UNITED STATES  
NUCLEAR REGULATORY COMMISSION

LICENSEE: Florida Power and Light Company

FACILITY: St. Lucie Nuclear Plant, Unit 1

SUBJECT: SUMMARY OF MEETING ON OCTOBER 24, 2000, REGARDING  
ST. LUCIE UNIT 1 EMERGENCY DIESEL GENERATOR ALLOWED  
OUTAGE TIME EXTENSION (TAC NO. MA 7205)

ST. LUCIE - UNIT #1  
FLOOR PLAN UNIT 1 CONTROL ROOM  
ELEVATION 62.00'

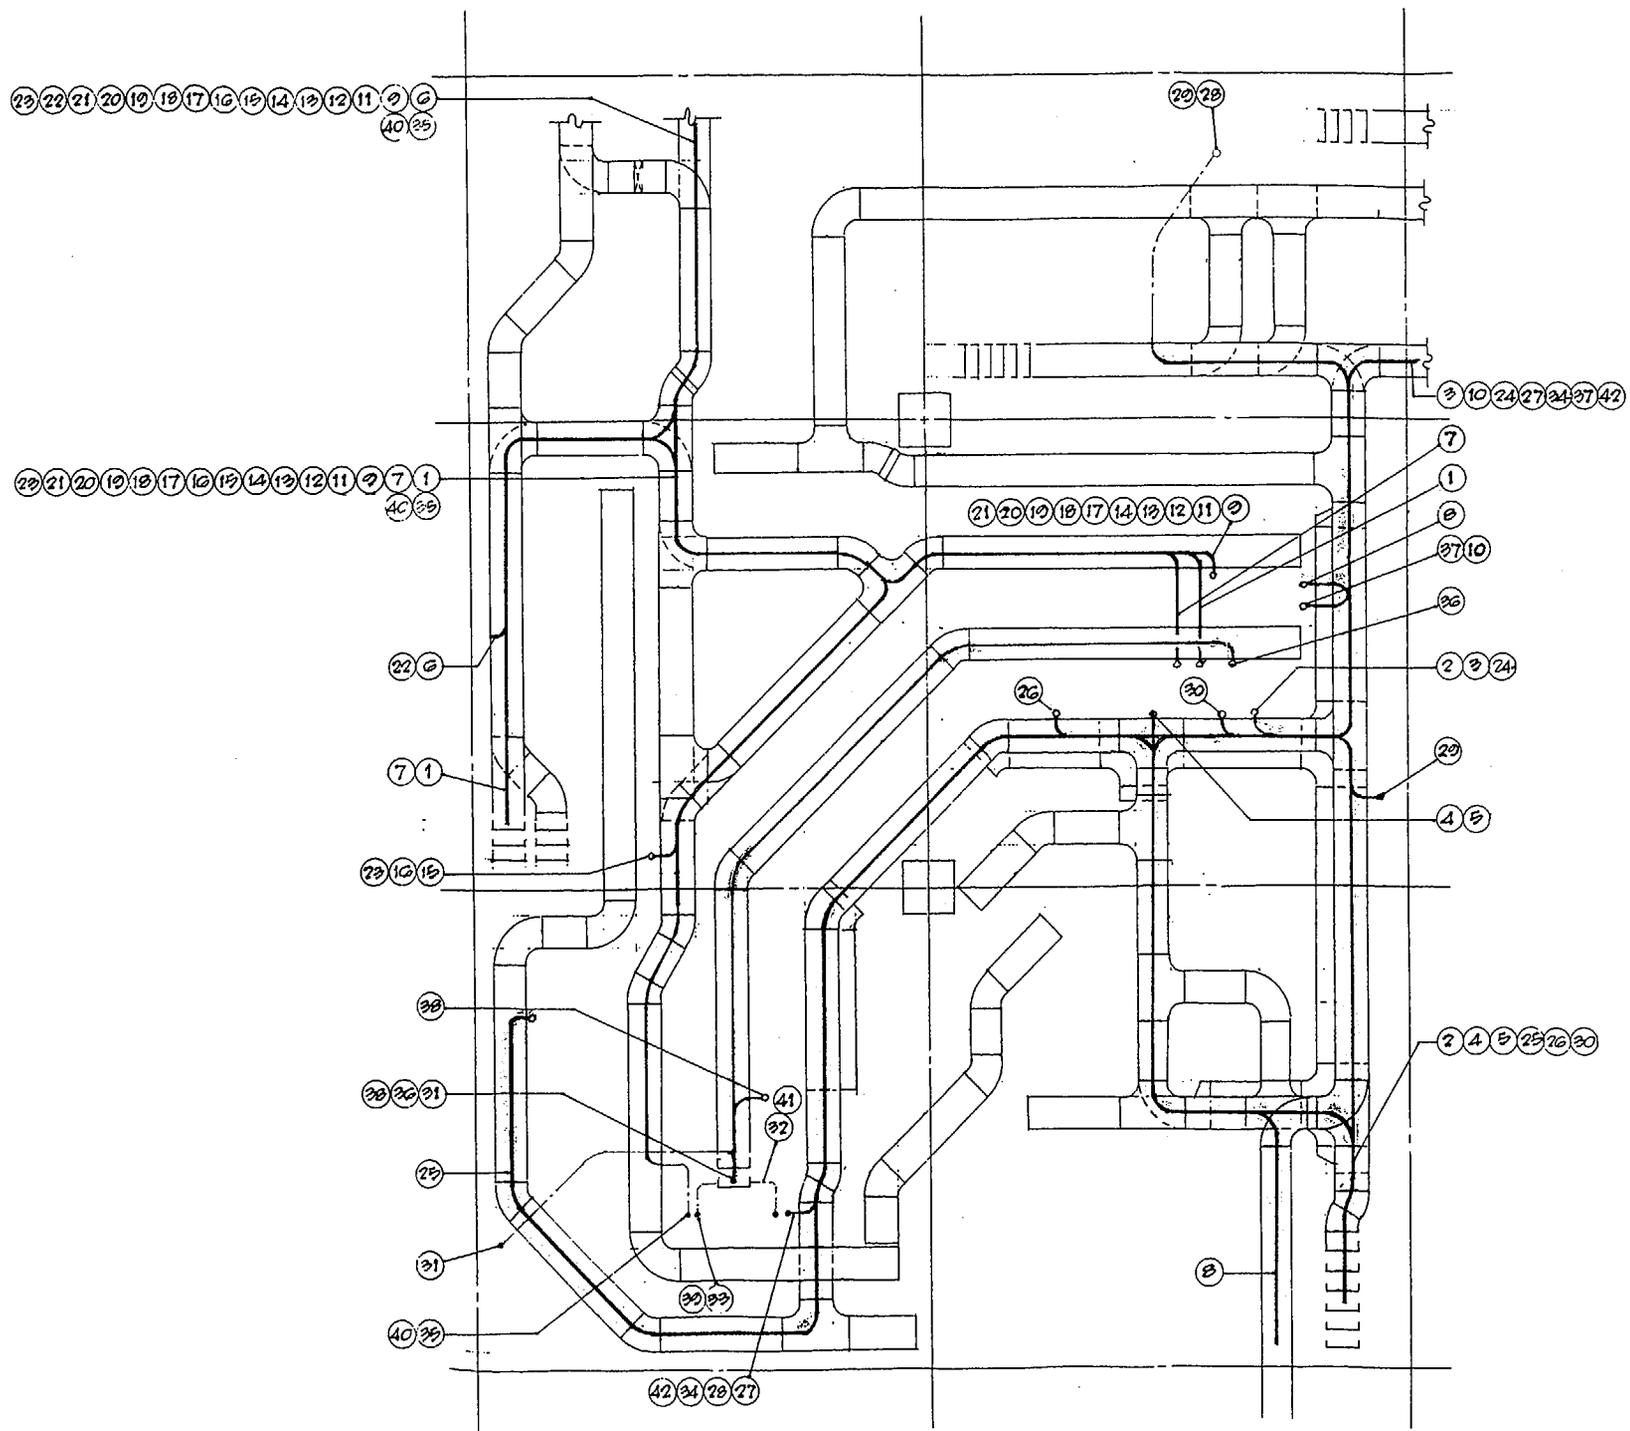
1. Responses to the NRC staff concerns that should include quantitative reevaluation and elaboration of the fire risk analysis in the CSR and CR. The elaboration of the fire risk should include a discussion of critical components, ignition sources, cable trays and cable arrangement, location of critical cables, and transient combustible control.

2. Tier 2 commitments when in the extended AOT, such as significant restrictions on hot-work in the CSR, continuous fire watch, plant fire protection walkdown prior to entering an extended AOT, and potential thermographic examination of high-risk ignition sources in the CSR and the CR.
